UNITED STATES PATENT AND TRADEMARK OFFICE

APPLICATION NO.	FILING DATE	FIRST NAMED INVENTOR	ATTORNEY DOCKET NO.	CONFIRMATION NO.
10/088,114	07/18/2002	Hiroshi Inoue	NIP-275	8078

Office Action Summary

DETAILED ACTION

FIG. 13

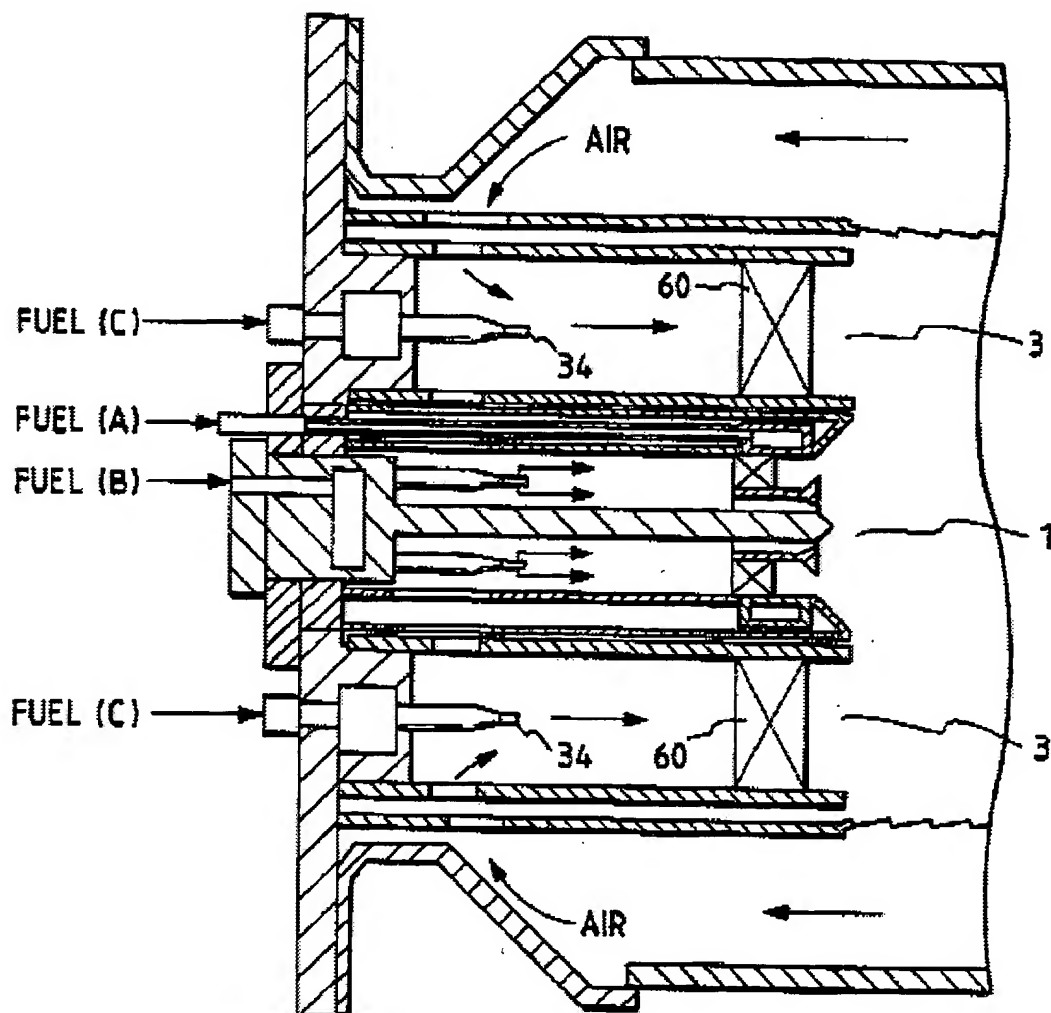
21. **Claims 1 & 7** are rejected under 35 U.S.C. 102(b) as being anticipated by (5,660,045) to Ito et al.

Ito et al., Figure 13 as displayed above discloses according to applicant's **claims 1 & 7**, a gas turbine combustor comprising diffusive combustion nozzles {inner ring of fuel B fed nozzles} which inject fuel and air into a combustion chamber and form a diffusive combustion flame, outer {next to air leader line connected to (60)} and inner {next to reference sign (34)} walls which form an annular premixing flow passage {framed by (60)} and premixing nozzles (34) which are disposed in the premixing flow passage and form a premixing combustion flame by injecting premixed gas formed by premixing fuel and air into the combustion chamber, characterized in that a plurality of the premixing nozzles (34) are arranged in the premixing flow passage {framed by (60)}; opening portions permitting air to flow in are provided at the outer wall {air vents connected to (60)} so that the air flowed into the premixing flow passage forms swirling flow with respect to the premixing nozzles (34); and the opening portions are disposed in circumferential direction and are provided one for every adjacent two premixing nozzles (34). See Ito et al., Figures 1-15, and respective portions, abstract, col. 11 lines 49-65 of the detailed description.

FIG. 4

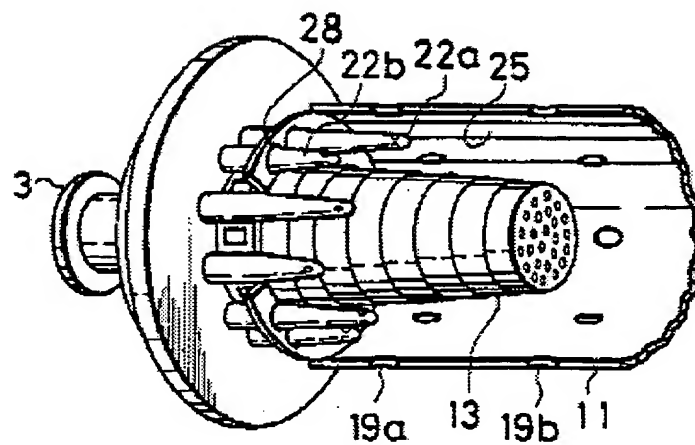
Kuroda et al., Figures 3 & 4 as immediately displayed above discloses according to applicant's **claims 1, 4 & 7**, a gas turbine combustor comprising diffusive combustion nozzles {See Fig. 4, inner ring of fuel fed nozzles} which inject fuel and air into a combustion chamber (12) and form a diffusive combustion flame, outer {(12), (42b)} and inner {(11), (38)} walls which form an annular premixing flow passage {framed by (37), (42a), (42b)} and premixing nozzles (32) which are disposed in the premixing flow passage and form a premixing combustion flame by injecting premixed gas formed by premixing fuel and air into the combustion chamber (12), characterized in that a plurality of the premixing nozzles (32) are arranged in the premixing flow passage {framed by (37), (42a), (42b)}; opening portions {between (43a)-(43b) & between (12)-(43b)} permitting air to flow in are provided at the outer wall {between (43a)-(43b) & between (12)-(43b)} so that the air flowed into the premixing flow passage forms swirling flow with respect to the premixing nozzles (32); and the opening portions {circumferentially framed volume sections between (43a)-(43b) & between (12)-(43b) encompassing every two nozzles (32)} are disposed in circumferential direction and are provided one for every adjacent two

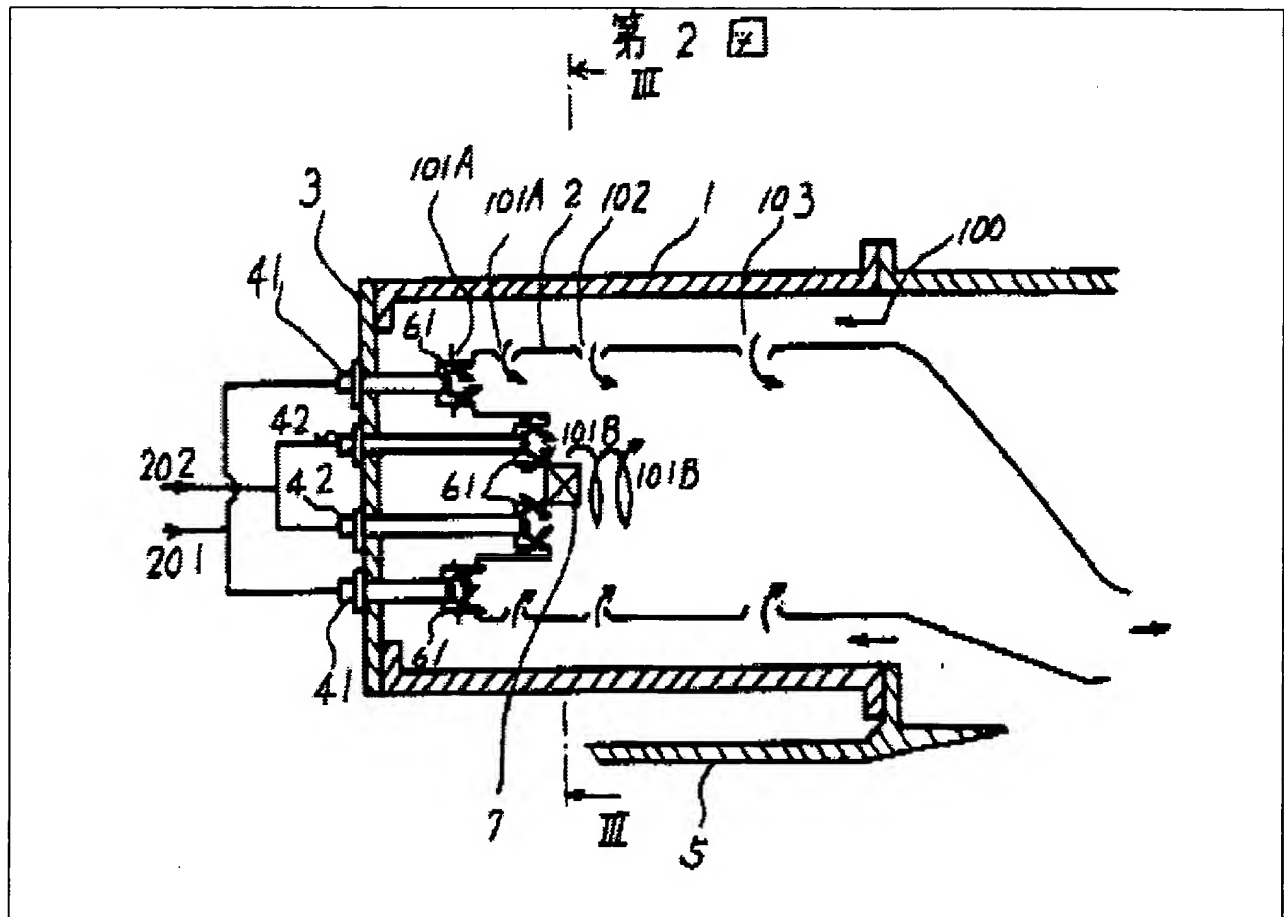
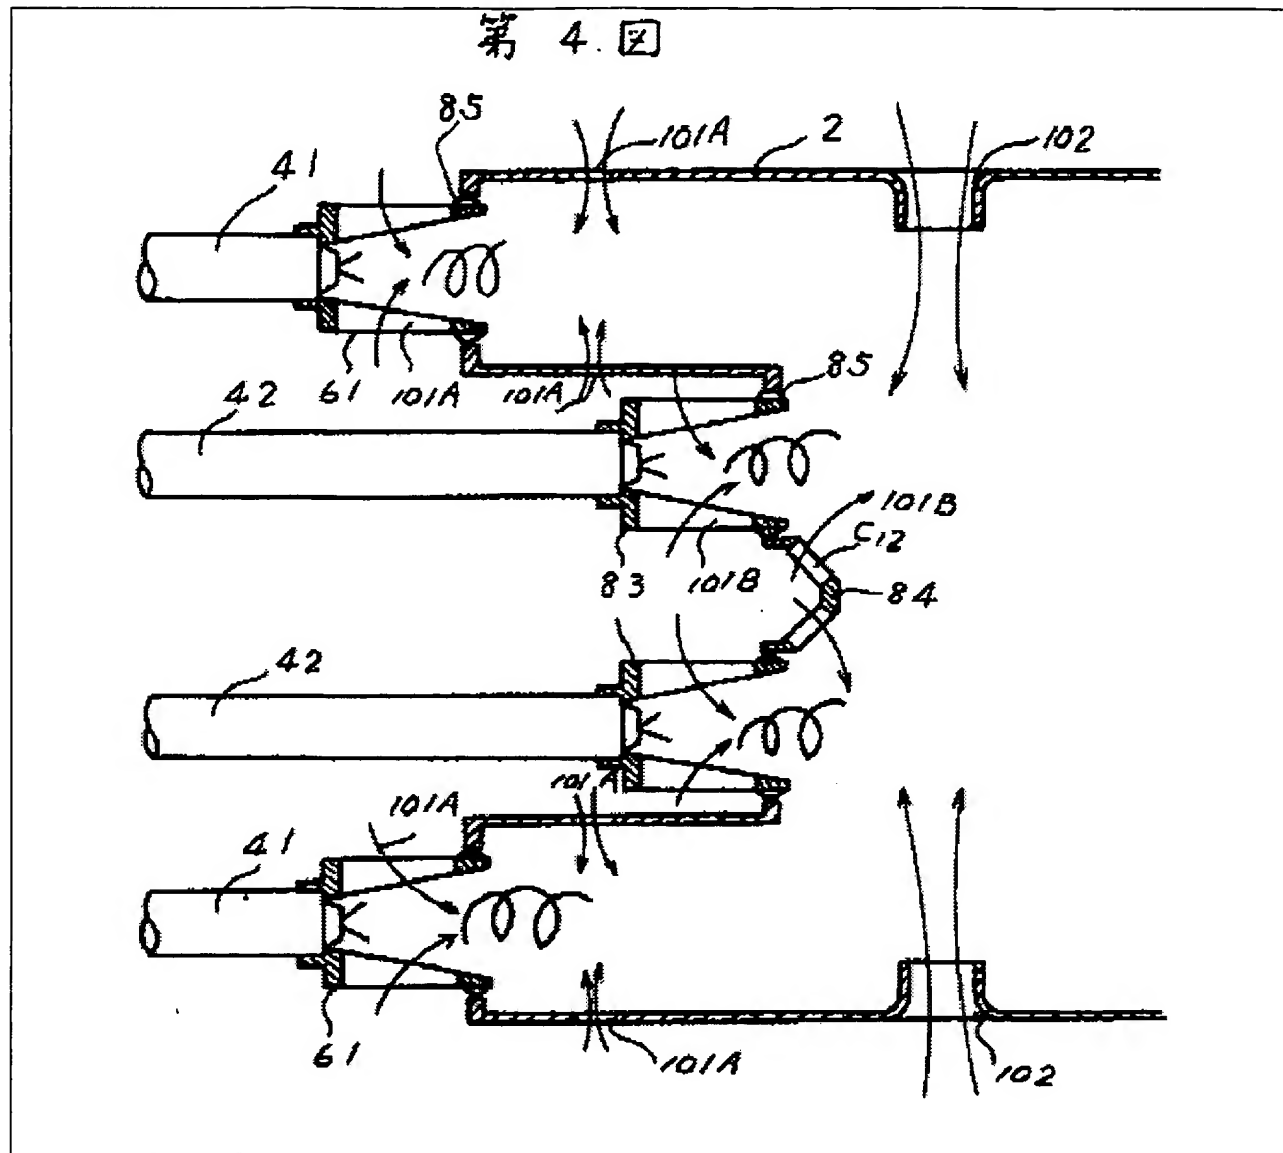
23. **Claims 1 & 7** are rejected under 35 U.S.C. 102(b) as being anticipated by (JP-355046309-A) to Kusaba et al.

Kuroda et al., Figures 2 & 4 as immediately displayed above discloses according to applicant's **claims 1 & 7**, a gas turbine combustor (1) comprising diffusive combustion nozzles {inner ring of fuel fed nozzles (42)} which inject fuel and air into a combustion chamber (2) and form a

diffusive combustion flame, outer {(2), (61)} and inner {containing (101A) next to (42)} walls which form an annular premixing flow passage {inline with (41)} and premixing nozzles (41) which are disposed in the premixing flow passage and form a premixing combustion flame by injecting premixed gas formed by premixing fuel and air into the combustion chamber (2), characterized in that a plurality of the premixing nozzles (41) are arranged in the premixing flow passage {inline with (41)} opening portions (101A) permitting air to flow in are provided at the outer wall {(2), (61)} so that the air flowed into the premixing flow passage forms swirling flow with respect to the premixing nozzles (41); and the opening portions {(101A) encompassing every two nozzles (41)} are disposed in circumferential direction and are provided {at least} one for every adjacent two premixing nozzles (41). See Kusaba et al., Figures 2 & n4 and English abstract.

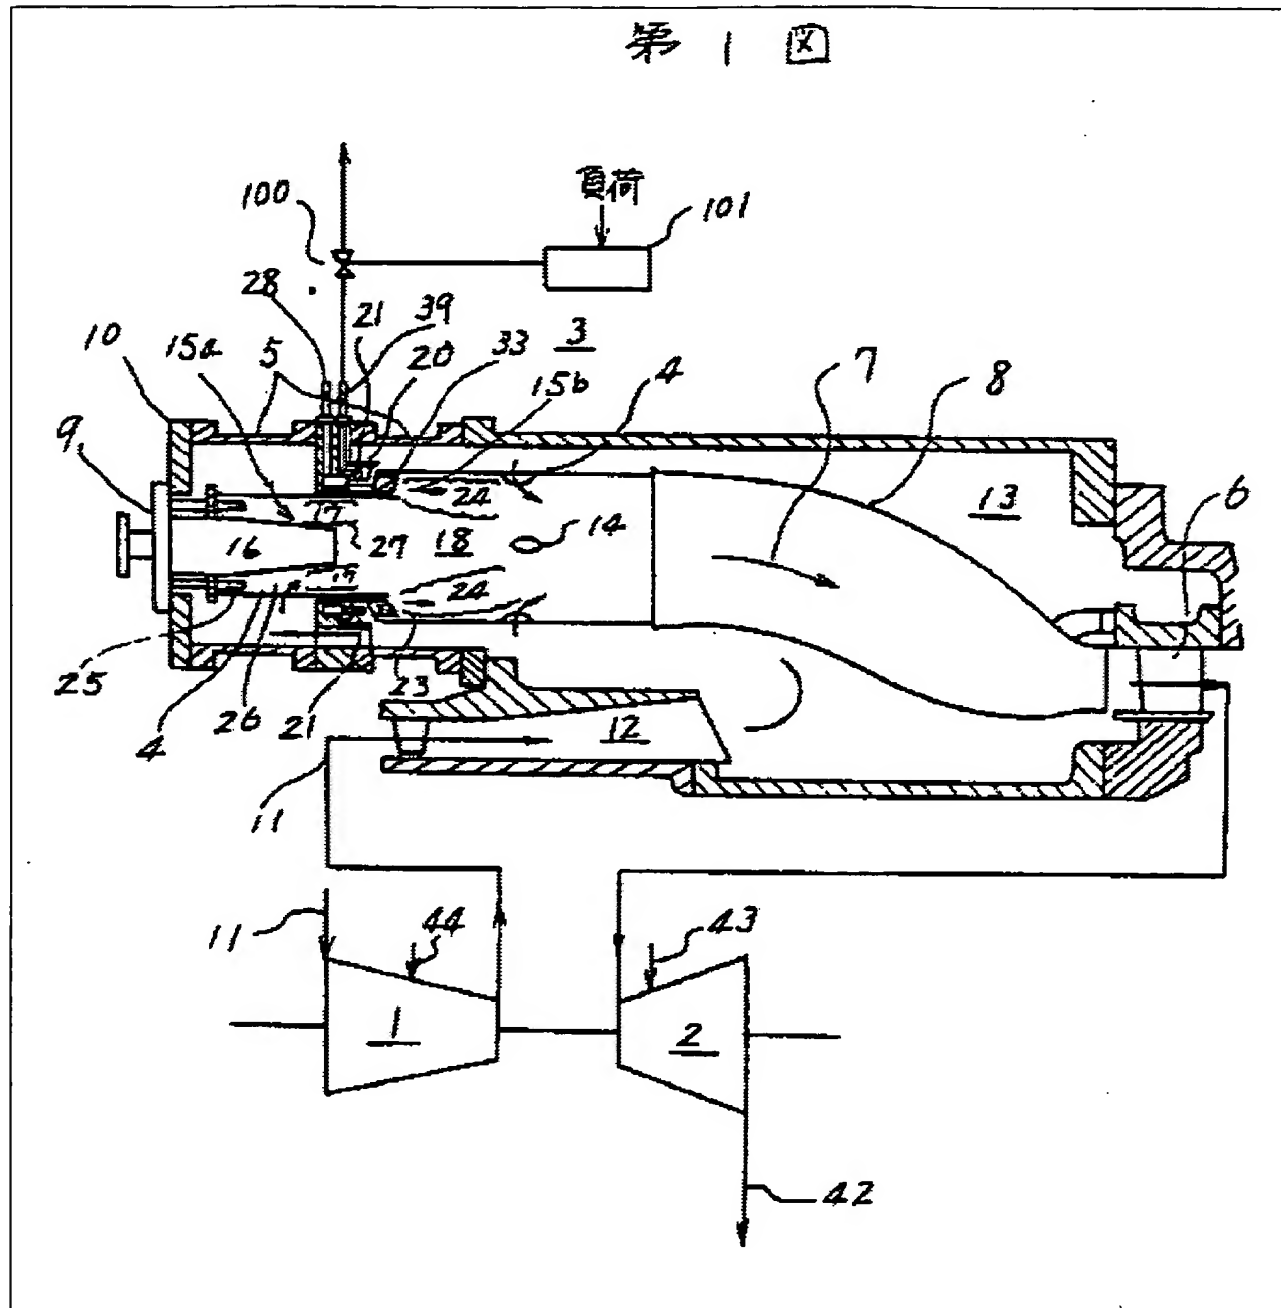
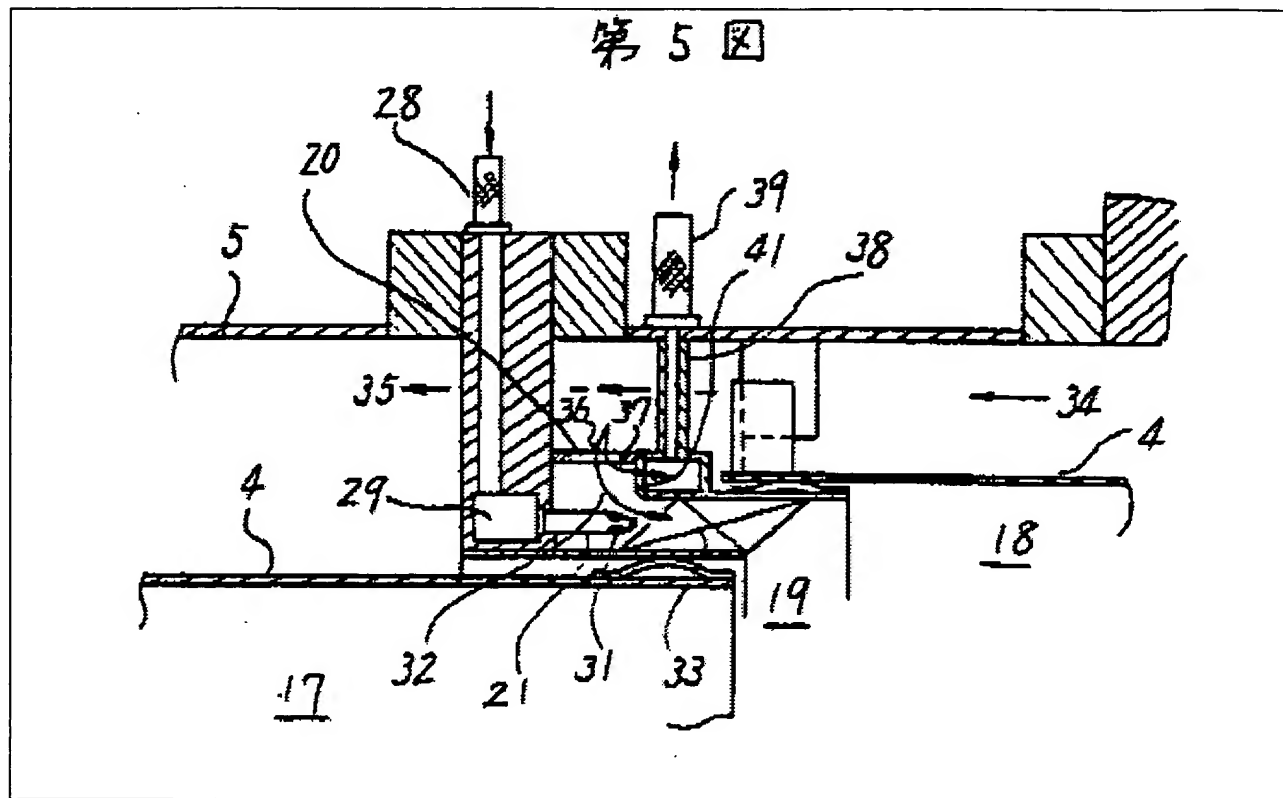
24. **Claims 1, 4 & 7** are rejected under 35 U.S.C. 102(b) as being anticipated by (JP-362175524-A) to Iizuka et al.

Iizuka et al., Figures 2 & 4 as immediately displayed above discloses according to applicant's **claims 1, 4 & 7**, a gas turbine combustor (4) comprising diffusive combustion nozzles {inner ring of fuel fed nozzles (25)} which inject fuel and air into a combustion chamber (4) and form a diffusive combustion flame, outer and inner walls {framed by (4)} which form an annular premixing flow passage {inline with (21)} and premixing nozzles (21) which are disposed in the premixing flow passage and form a premixing combustion flame by injecting premixed gas formed by

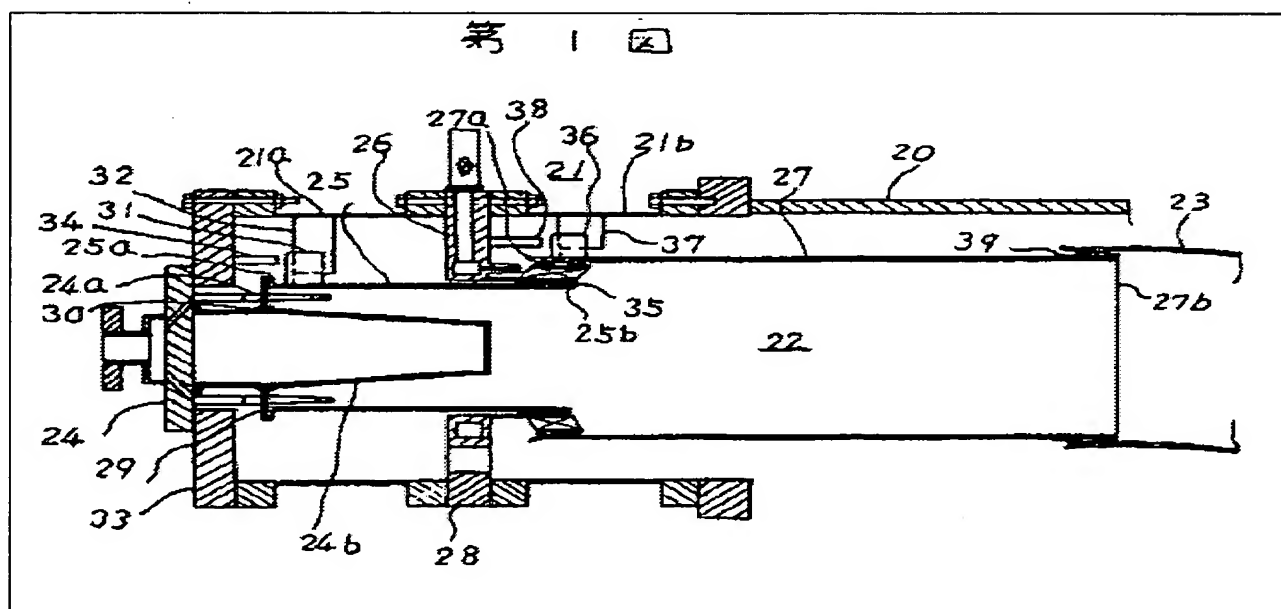
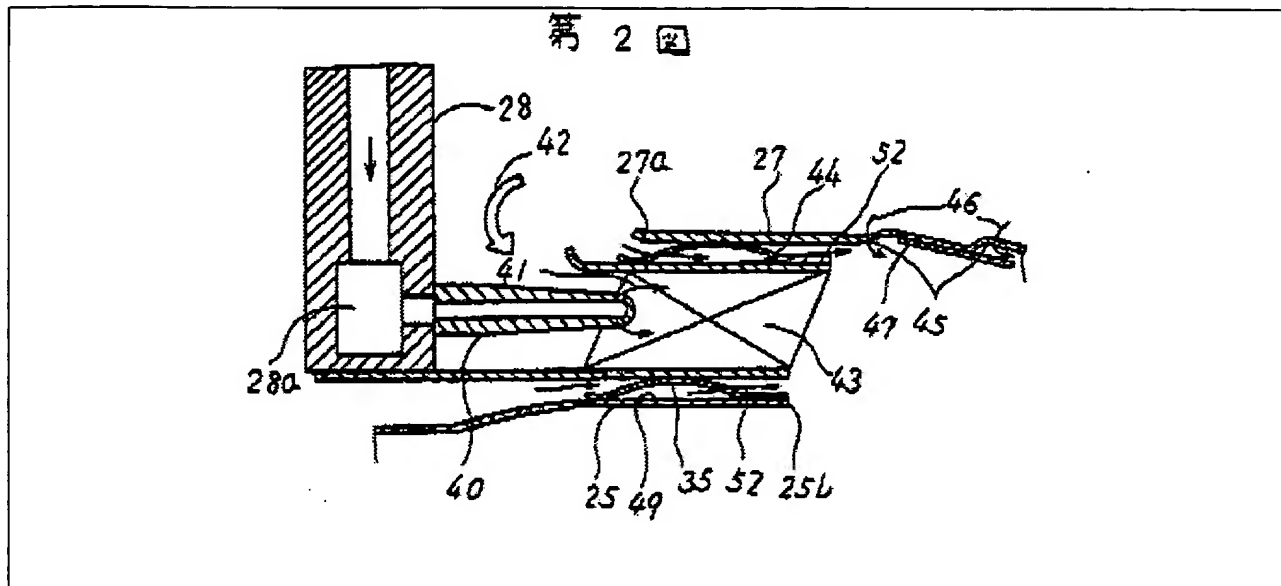
25. **Claims 1-3, 7, 9, 10 & 12-17** are rejected under 35 U.S.C. 102(b) as being anticipated by (JP-361119920-A) to Iizuka et al.

Iizuka et al., Figures 2 & 4 as immediately displayed above discloses according to applicant's **claims 1-3, 7, 9, 10 & 12-17**, a gas turbine combustor (22) comprising diffusive combustion nozzles {inner ring of fuel fed nozzles (24a)} which inject fuel and air into a combustion chamber (22) and form a diffusive combustion flame, outer and inner walls {framed by member (27)-(49) & means for swirling (43)} which form an annular premixing flow passage {inline with (40)} and premixing nozzles (40) which are disposed in the premixing flow passage and form a premixing combustion flame by injecting premixed gas formed by premixing fuel and air into the combustion chamber (22) characterized in that a plurality of the

premixing nozzles (40) are arranged in the premixing flow passage {inline with (40)} opening portions {between (27) & (43), between (49) & (43) and at (41)} permitting air to flow in are provided at the outer wall(s) {(27), (49) and framed by (43)} so that the air flowed into the premixing flow passage forms swirling flow with respect to the premixing nozzles (40); and the opening portions {circumferentially framed volume sections between (27) & (43), between (49) & (43) and at (41) encompassing every two nozzles (40)} are disposed in circumferential direction and are provided {at least} one for every adjacent two premixing nozzles (40) wherein the swirling flows at (41) can rotate in directions opposite each other in the circumferential direction {especially during turbine gas flow transients like as during faulty starts or shutdowns} for every adjacent two premixing nozzles (40). See Iizuka et al., Figures 1 & 2, and English abstract.
